Geotechnical Engineering Report

Proposed Acorn Valley Development

83 Christie Drive, Dorchester, Ontario

Revised Report

Project : Proposed Residential Subdivision

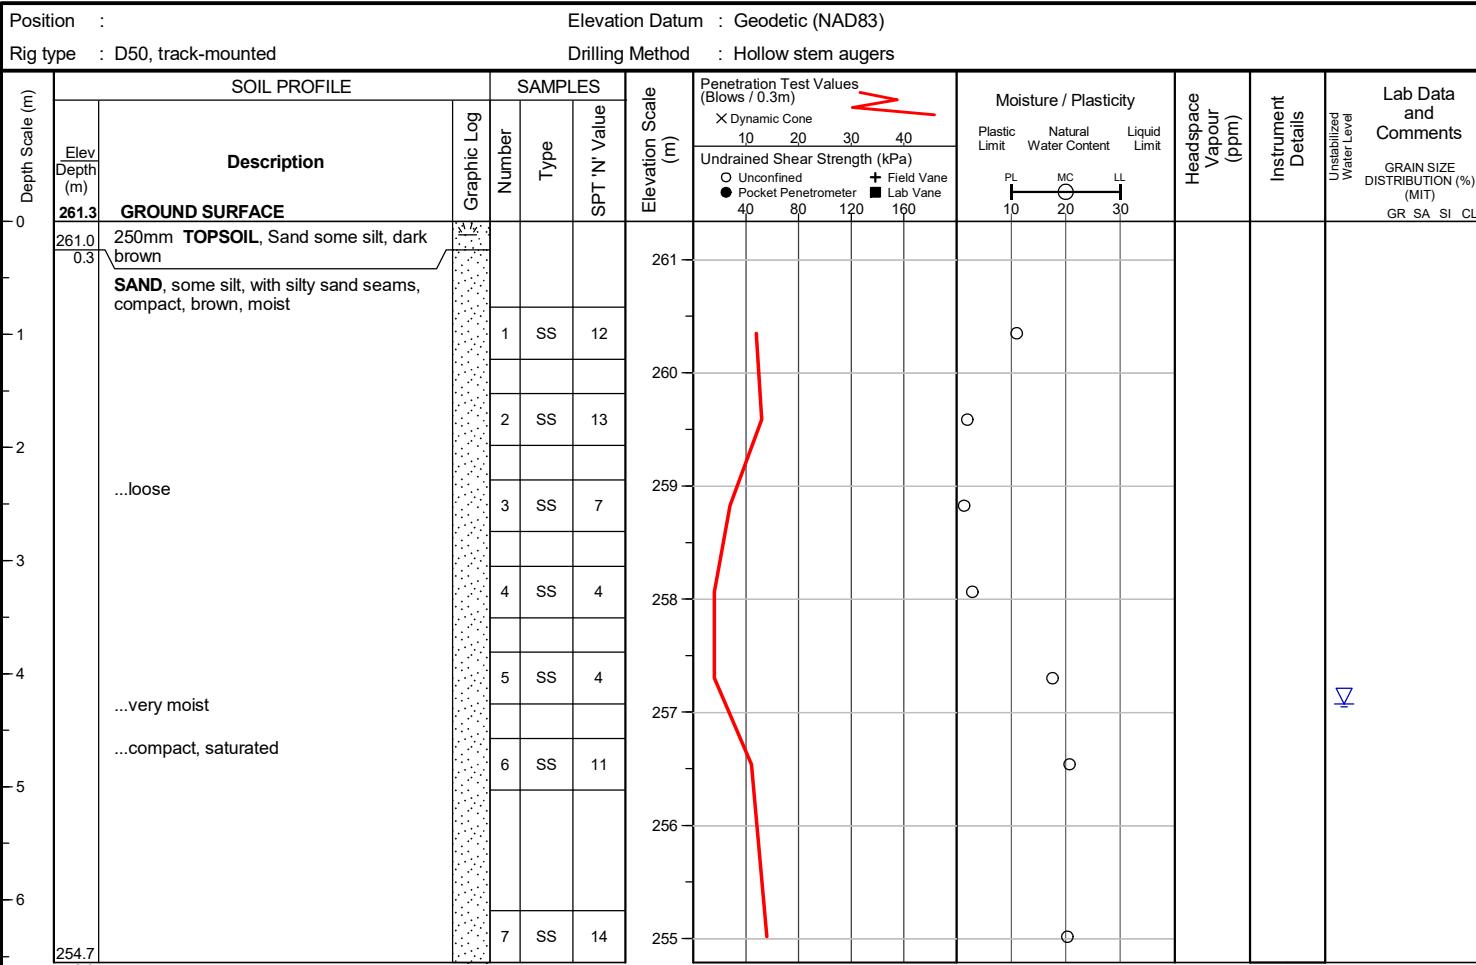
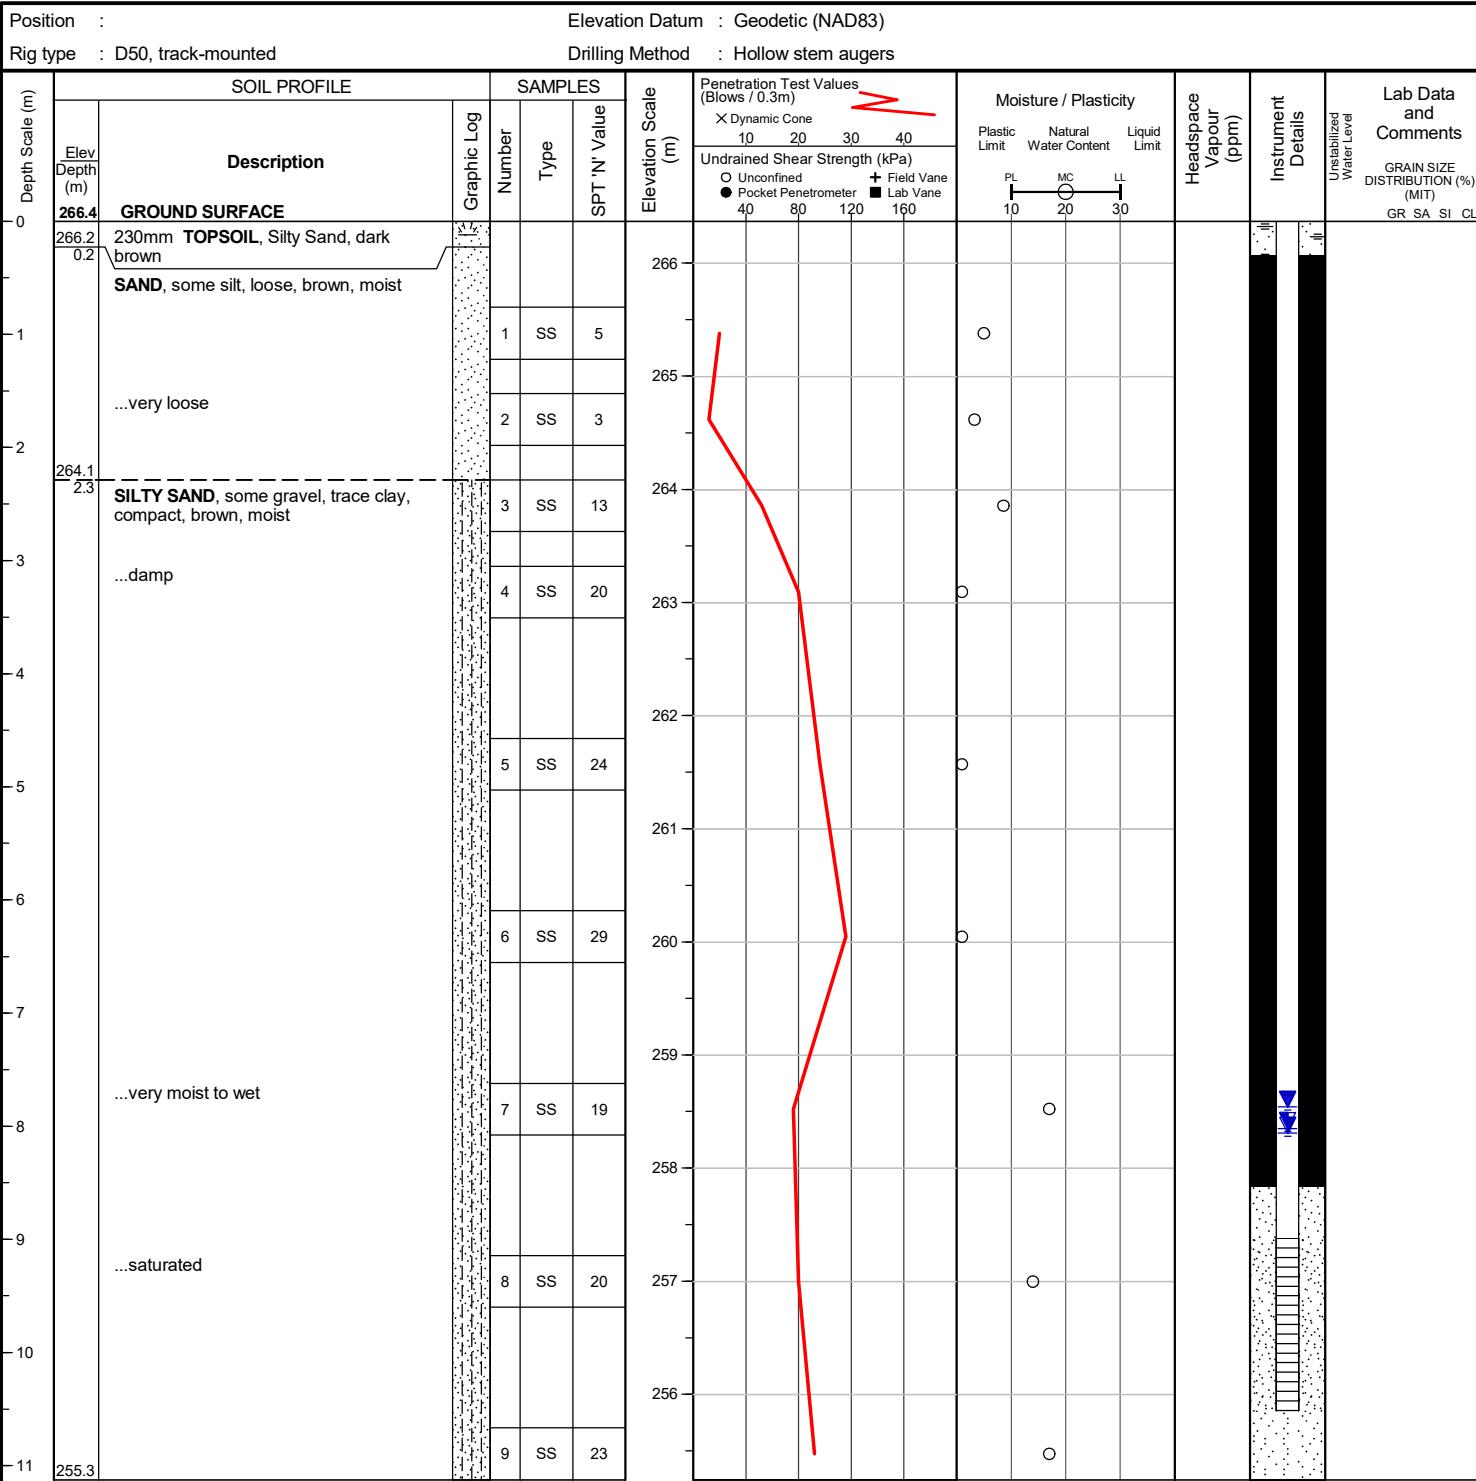
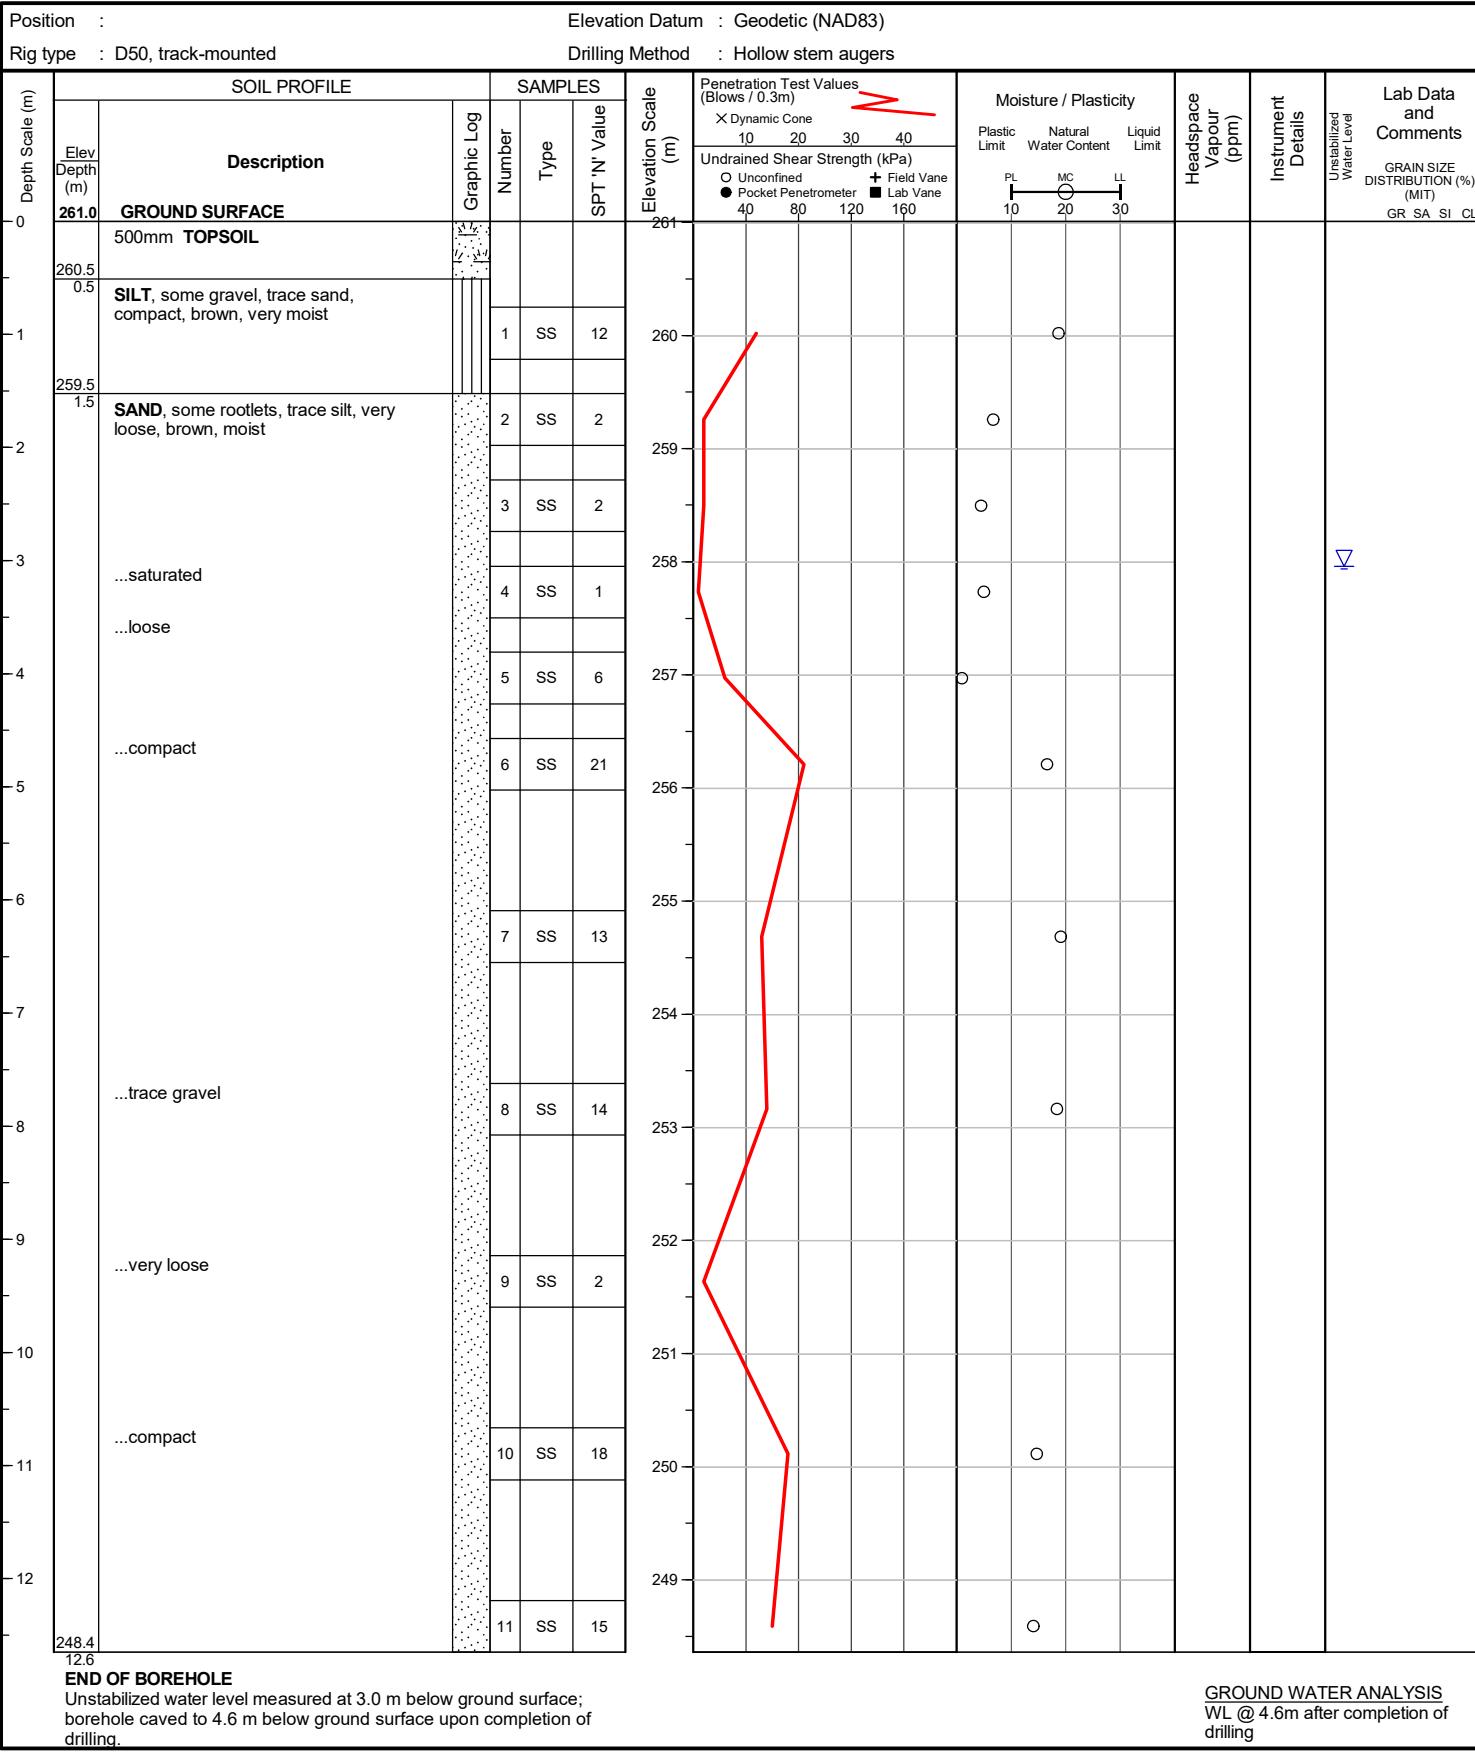
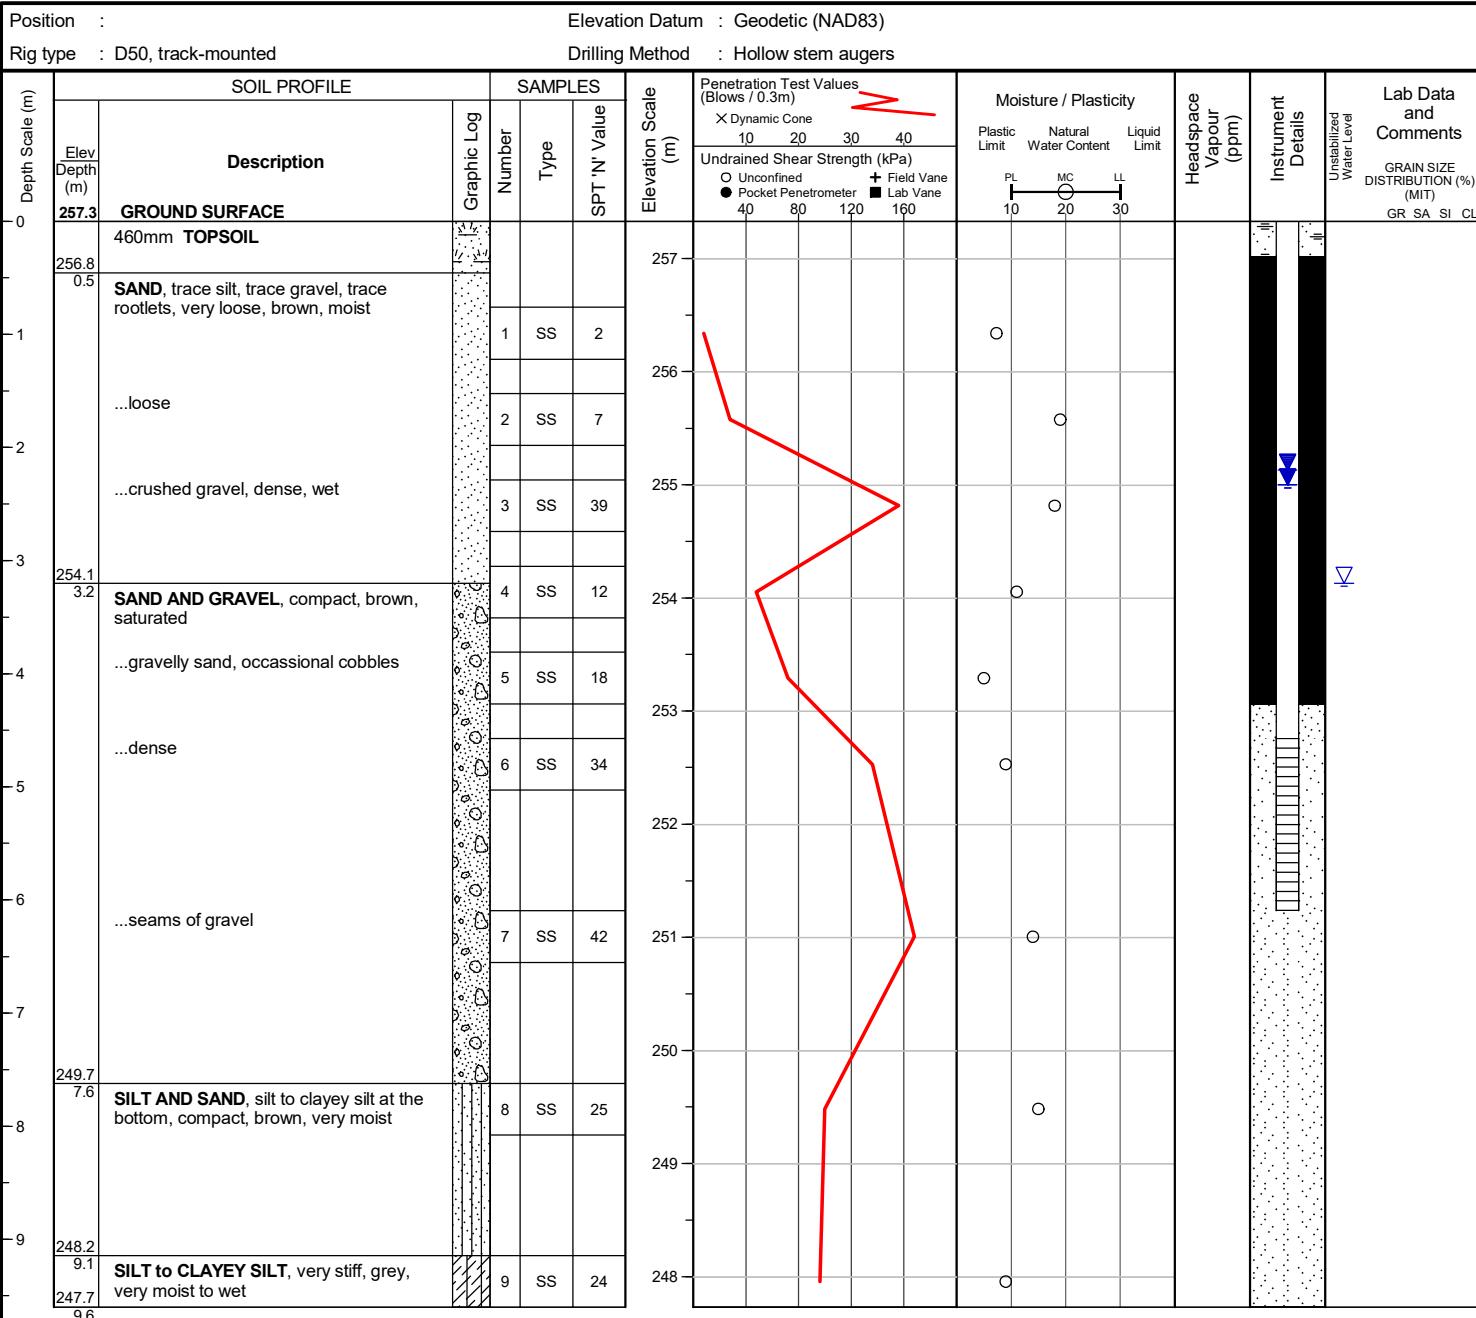
ITEM No.	Section	CLIENT COMMENTS	Englobe Response	CLIENT DECISION/CONCLUSION
G5		The log for borehole 10 in Appendix C shows the groundwater level at approximately 2.25 m below ground but is stated as 3.23m in the body of the report. Please confirm.	Updated borehole logs.	
G6		Please confirm that the 8 cross-sections shown are considered critical sections of the corresponding slopes.	As summarized in Table 5, the slope at Section 5-5' was considered the critical slope section and was therefore selected for analyses.	
G7		Please also include the 6m erosion access allowance on the detailed cross-sections.	Updated as requested	
G8	5.5	states that based on the findings of the analysis the proposed trail (in the vicinity of cross-section A-A') can be safely constructed without adversely affecting the long-term stability of the valley slope. No risk to life or property damage is anticipated. Please include decision on watermain as well as the trail.	Revised accordingly. Added recommendations for slope restoration.
